UNITED STATES PATENT AND TRADEMARK OFFICE

APPLICATION NO.	FILING DATE	FIRST NAMED INVENTOR	ATTORNEY DOCKET NO.	CONFIRMATION NO.
10/531,834	04/18/2005	Taciana de Abreu e Silva	130033-1000	3760
37058	7590	12/14/2005	EXAMINER	
TIM HEADLEY GARDERE WYNNE SEWELL LLP 1000 LOUISIANA, SUITE 3400 HOUSTON, TX 77002			MENEZES, MARCUS	
		ART UNIT		PAPER NUMBER
				3677

Office Action Summary	Application No.	Applicant(s)
	10/531,834	SILVA ET AL.
	Examiner Marcus Menezes	Art Unit 3677

DETAILED ACTION

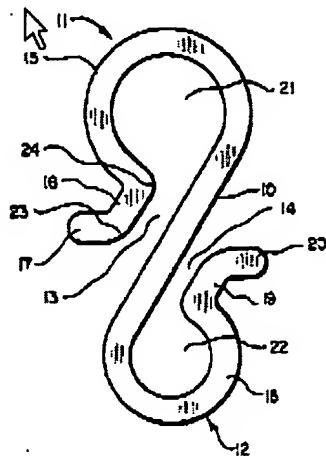
4. Claims 1-7 are rejected under 35 U.S.C. 102(b) as being clearly anticipated by Swenson et al. (US Patent No. 5,575,446).

Regarding claim 1-3, Swenson et al. discloses an item fastener characterized in that it is made in a single piece (11), comprising a central body (10) from which derives at least two lateral projections (15,18) that are extended in opposite directions and have

longitudinally opposite symmetrical shapes that are displaced outside and present lightly rounded internal grooves (21,22). (See below).

Regarding claims 4 and 5, Swenson et al. discloses a single piece (11) with a predetermined varying thickness. Regarding claims 6 and 7, Swenson et al. discloses a single piece made of a plastic that is flexible and non-corrosive. (See col. 3, lines 27-30).

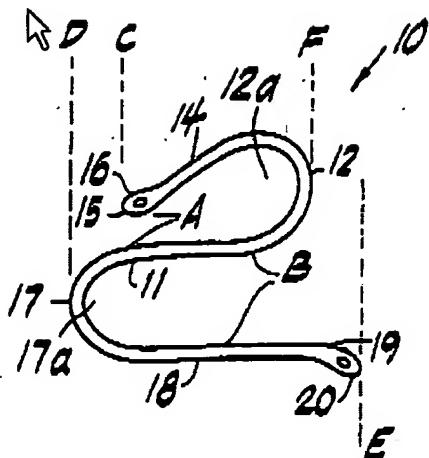
5. Claims 1-6 and 8 are rejected under 35 U.S.C. 102(b) as being clearly anticipated by Felcher (US Patent No. 5,497,636).

Regarding claim 1-3, Felcher discloses an item fastener characterized in that it is made in a single piece (10), comprising a central body (11) from which derives at least two lateral projections (14,18) that are extended in opposite directions and have longitudinally opposite symmetrical shapes that are displaced outside and present lightly rounded internal grooves (12a,17a). (See below).

Regarding claims 4 and 5, Felcher discloses a single piece (10) with a predetermined varying thickness. Regarding claims 6 and 8, Felcher discloses a single piece made of a wood that is flexible and non-corrosive. (See col. 3, lines 1-8).
